LINCOLN:

2013 MKZ

Figure 1 - Article 13-12-19

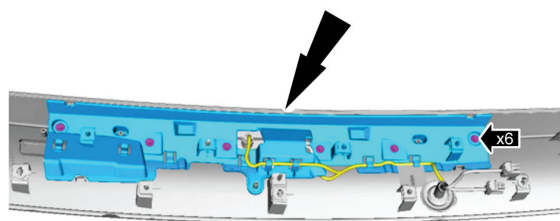
Some 2013 Lincoln MKZ vehicles may exhibit a concern of the luggage compartment lid lower moulding warping upward at the center. This condition may only be present after the vehicle is exposed to direct sunlight.

7. Apply 152 mm (6") of 3M™ Automotive Acrylic Plus Premium Attachment Tape or equivalent to the moulding and leave adhesive backer installed. (Figure 1)

- a. Firmly press tape into position.
